- UNDERCROFT LEVEL TO BE ENCLOSED WITH NEW WINDOWS TO FORM A SEALED ENVELOPE TO ENSURE THE HRV SYSTEM CAN WORK EFFICIENTLY
- ADDITION OF BATHROOM TO UNDERCROFT LEVEL
- LOCATION OF PASSIVE AIR INLET/ OUTLET TO EAST AND WEST ELEVATIONS
- FRONT PARTY FENCE SIMPLIFIED
- MINOR ADJUSTMENTS TO EXTERNAL FINISHES

MOD2021/0053

PROJECT  
TWO SEMI-DETACHED DWELLINGS  
WITH BASEMENT CARPARKING

52 LAUDERDALE AVENUE,  
FAIRLIGHT, NSW

UNDERCROFT FLOOR PLAN

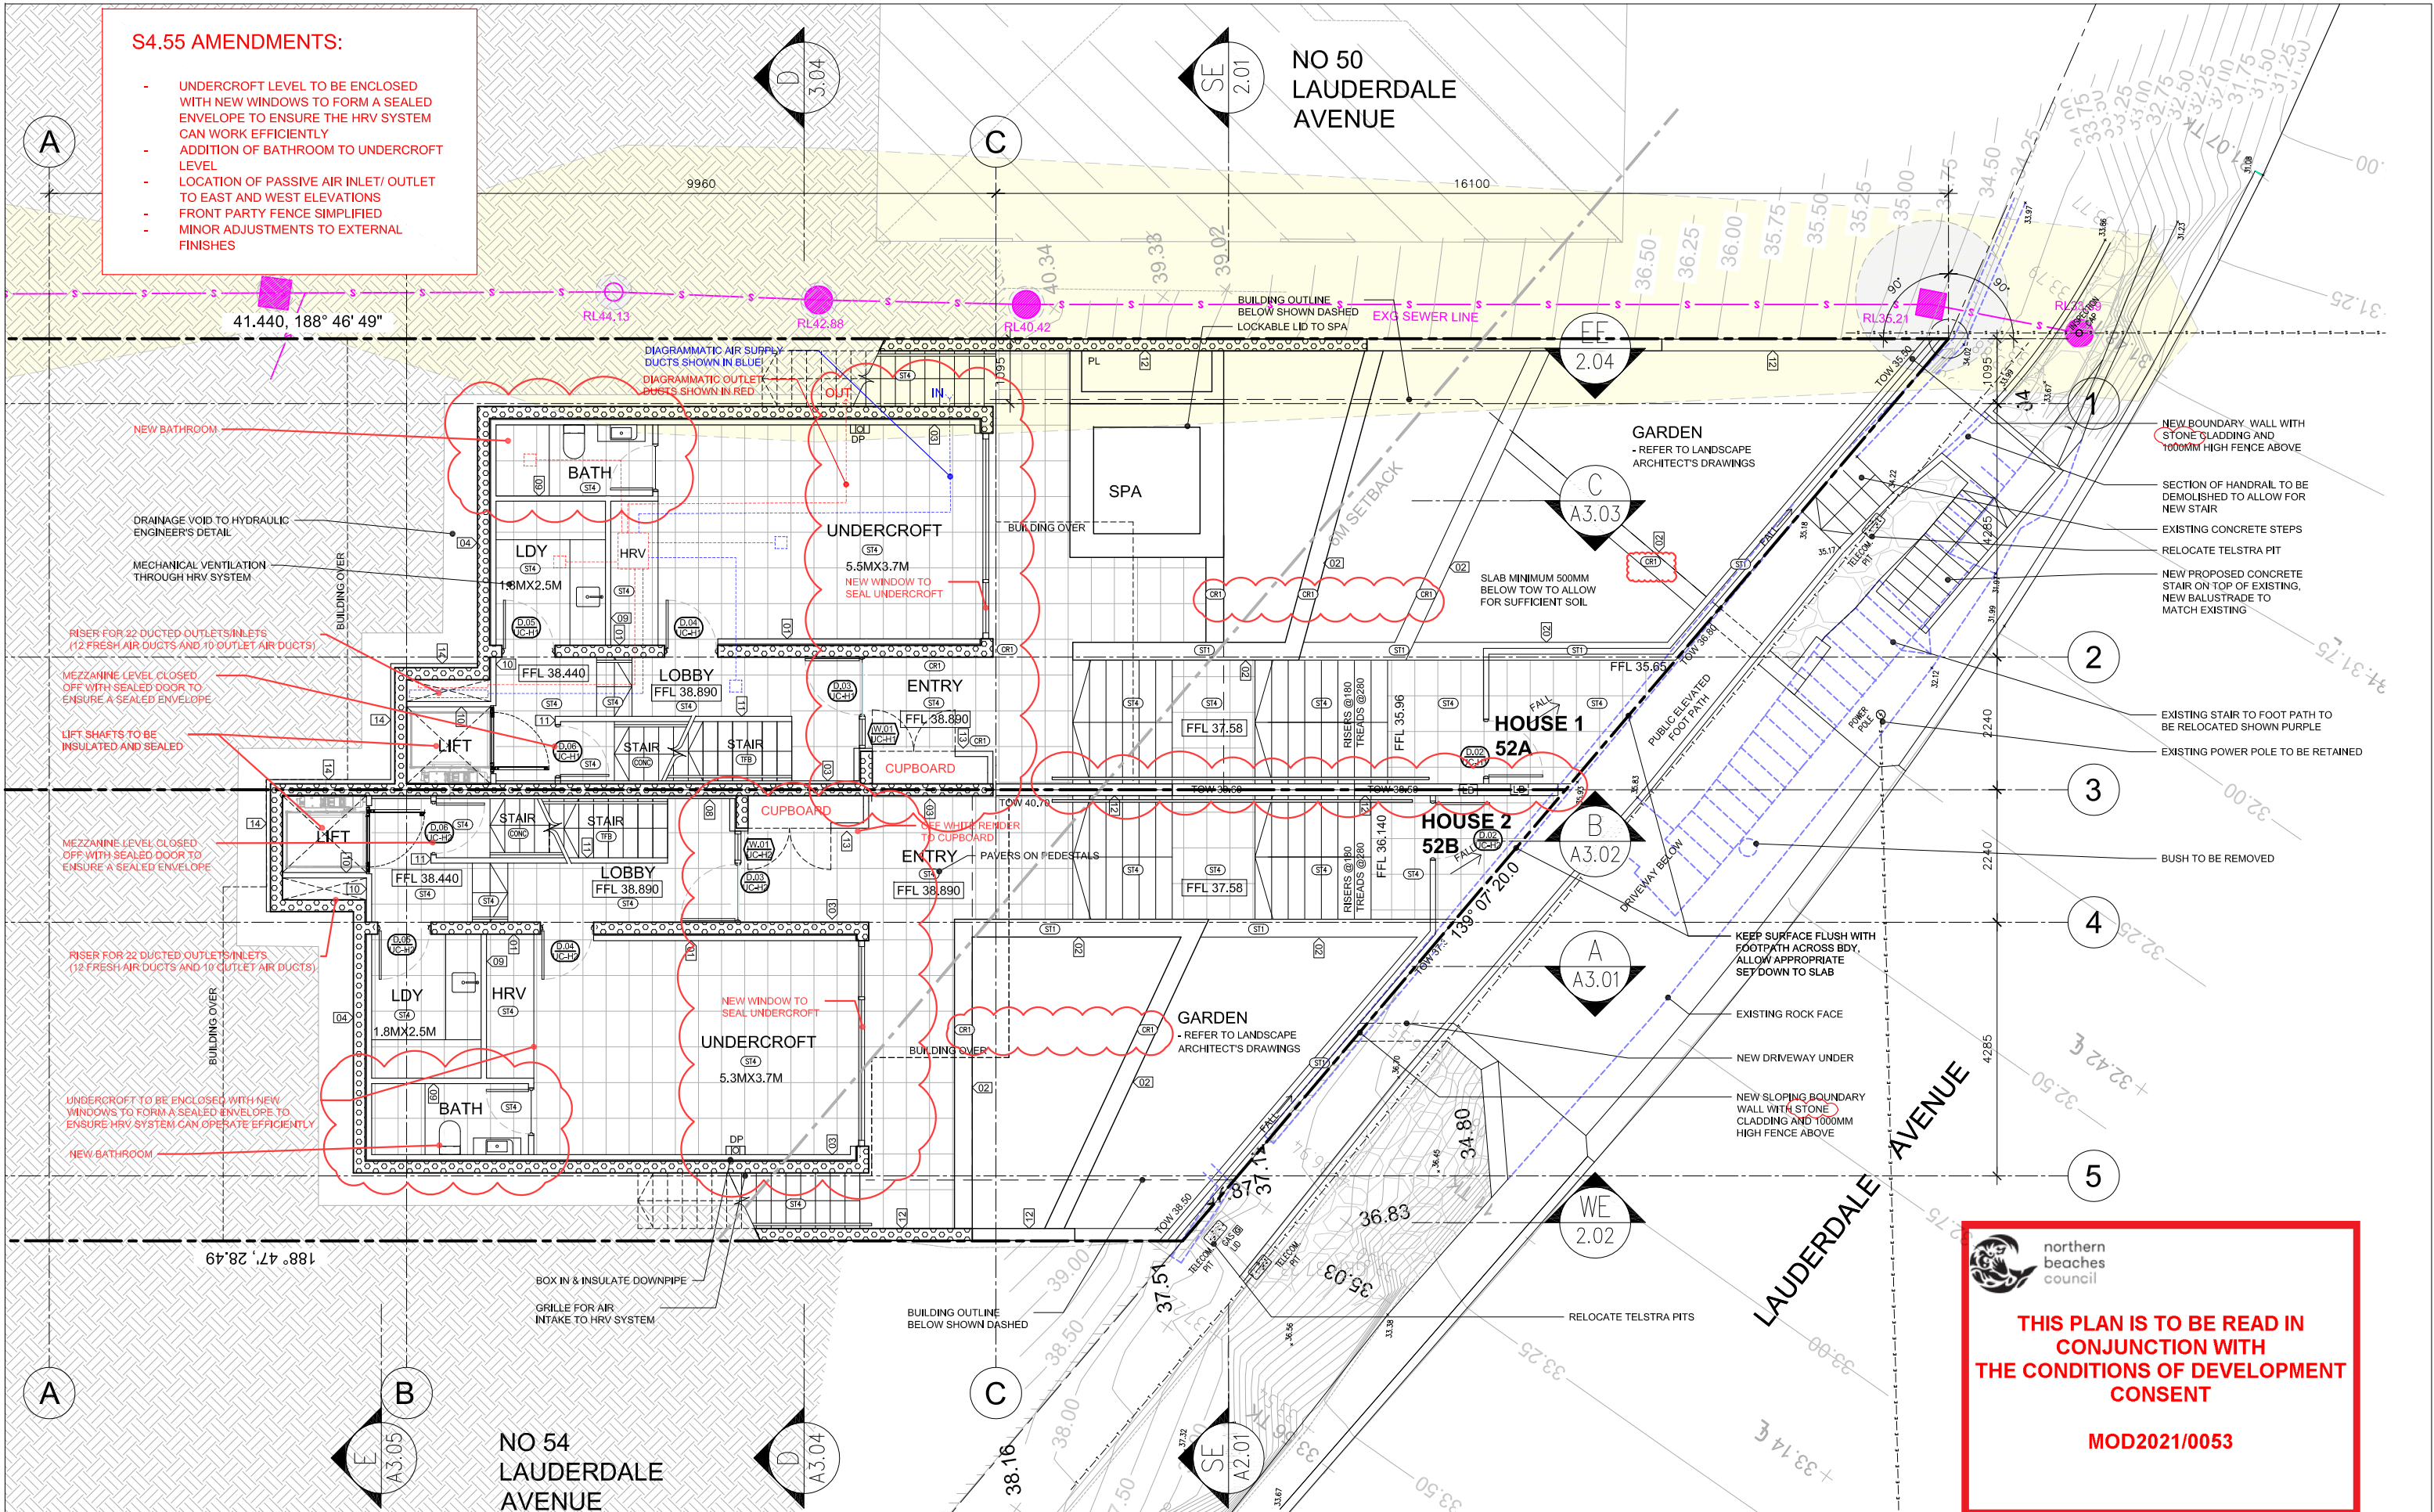
- UNDERCROFT LEVEL TO BE ENCLOSED WITH NEW WINDOWS TO FORM A SEALED ENVELOPE TO ENSURE THE HRV SYSTEM CAN WORK EFFICIENTLY
- ADDITION OF BATHROOM TO UNDERCROFT LEVEL
- LOCATION OF PASSIVE AIR INLET/ OUTLET TO EAST AND WEST ELEVATIONS
- FRONT PARTY FENCE SIMPLIFIED
- MINOR ADJUSTMENTS TO EXTERNAL FINISHES

WEST ELEVATION

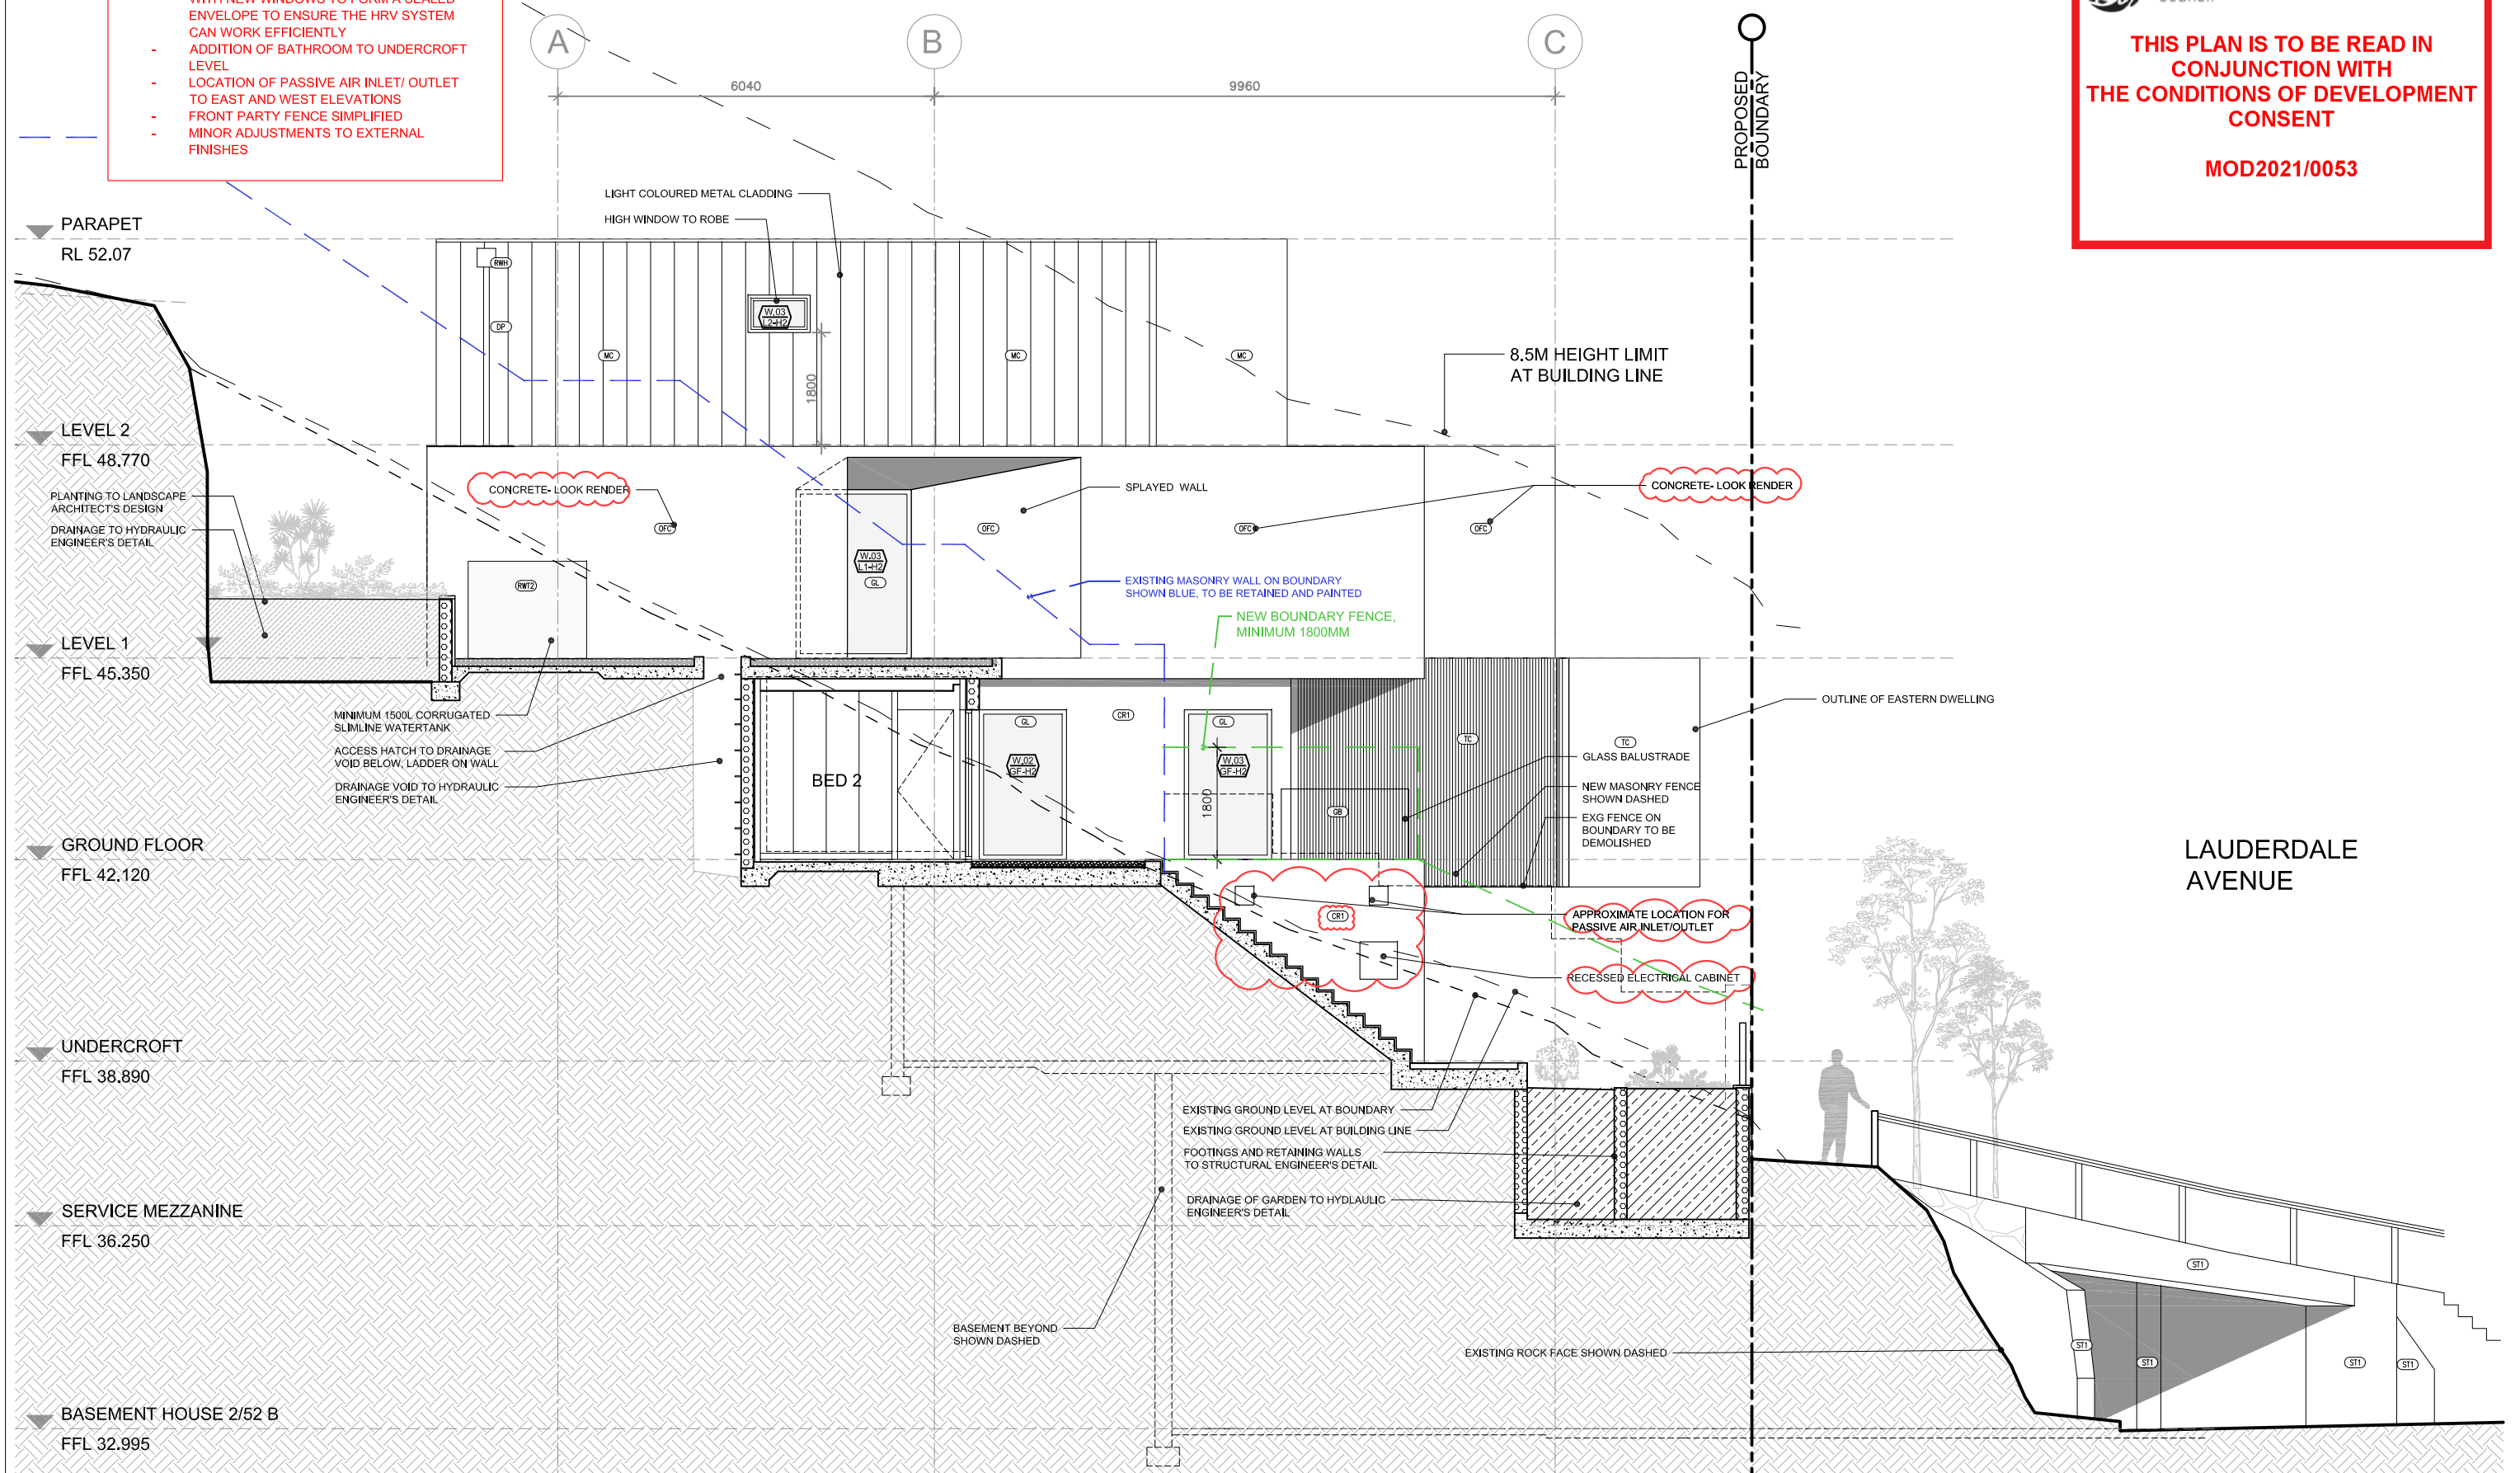
- UNDERCROFT LEVEL TO BE ENCLOSED WITH NEW WINDOWS TO FORM A SEALED ENVELOPE TO ENSURE THE HRV SYSTEM CAN WORK EFFICIENTLY
- ADDITION OF BATHROOM TO UNDERCROFT LEVEL
- LOCATION OF PASSIVE AIR INLET/ OUTLET TO EAST AND WEST ELEVATIONS
- FRONT PARTY FENCE SIMPLIFIED
- MINOR ADJUSTMENTS TO EXTERNAL FINISHES

EAST ELEVATION

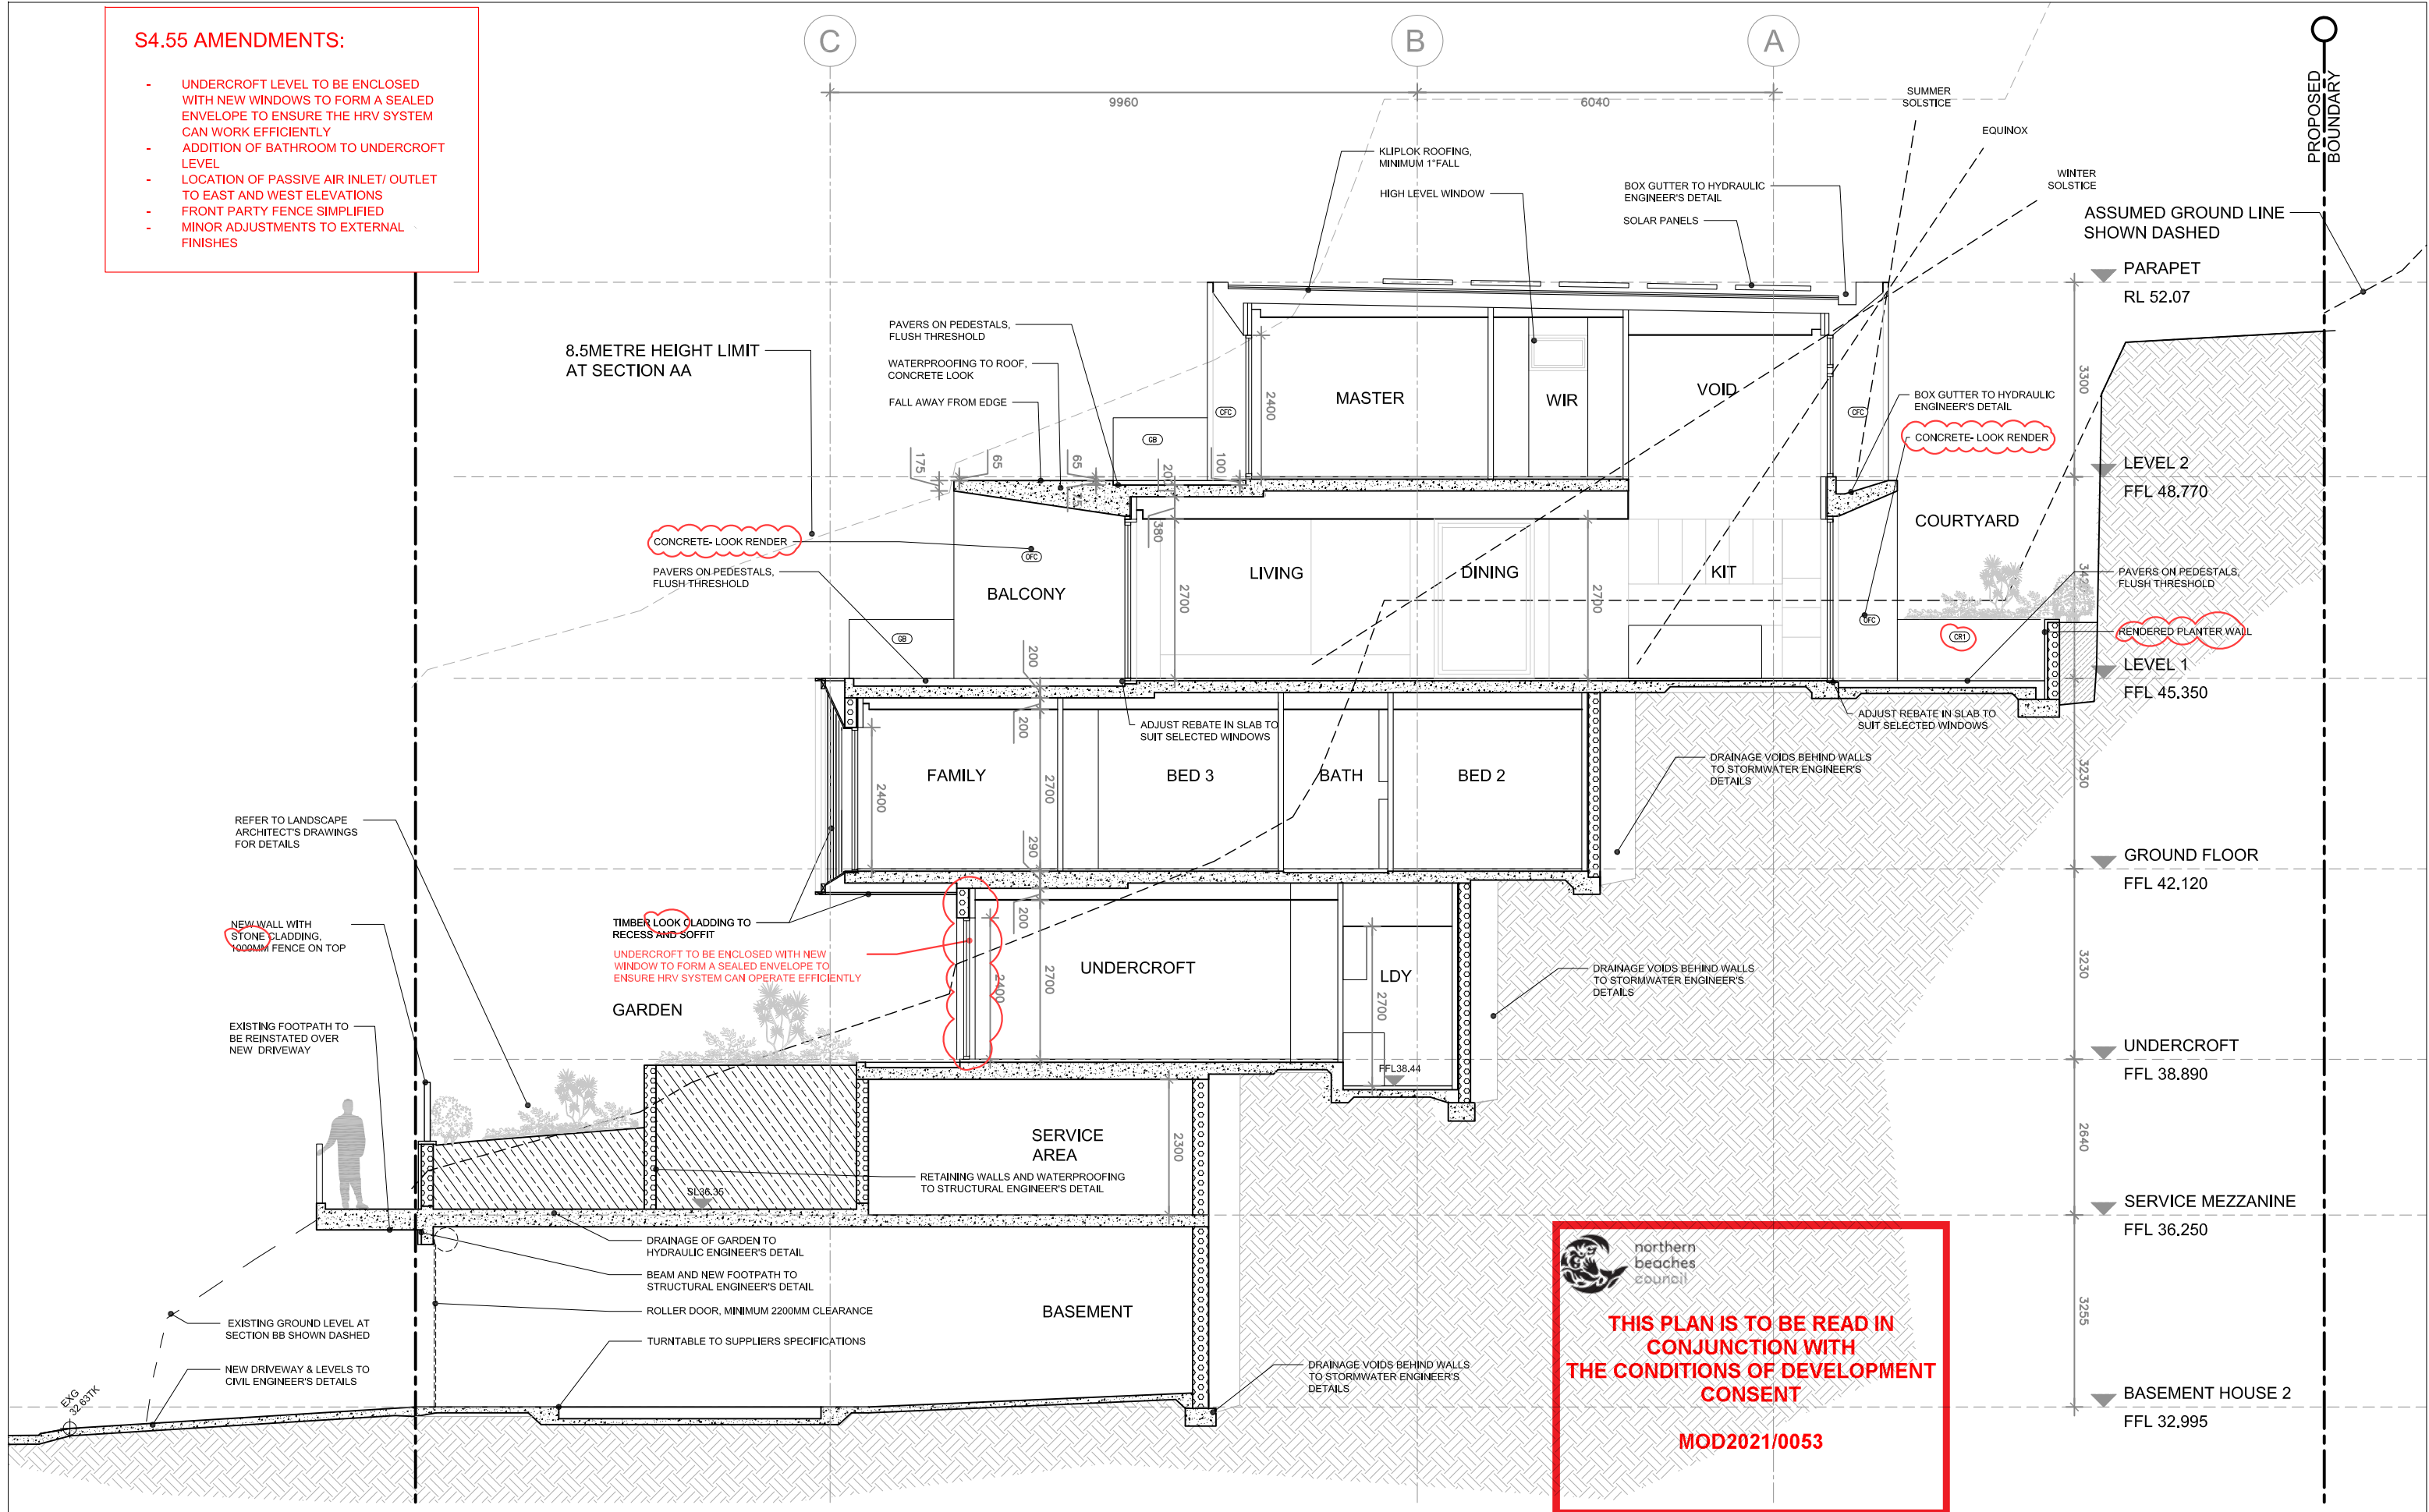
- UNDERCROFT LEVEL TO BE ENCLOSED WITH NEW WINDOWS TO FORM A SEALED ENVELOPE TO ENSURE THE HRV SYSTEM CAN WORK EFFICIENTLY
- ADDITION OF BATHROOM TO UNDERCROFT LEVEL
- LOCATION OF PASSIVE AIR INLET/ OUTLET TO EAST AND WEST ELEVATIONS
- FRONT PARTY FENCE SIMPLIFIED
- MINOR ADJUSTMENTS TO EXTERNAL FINISHES
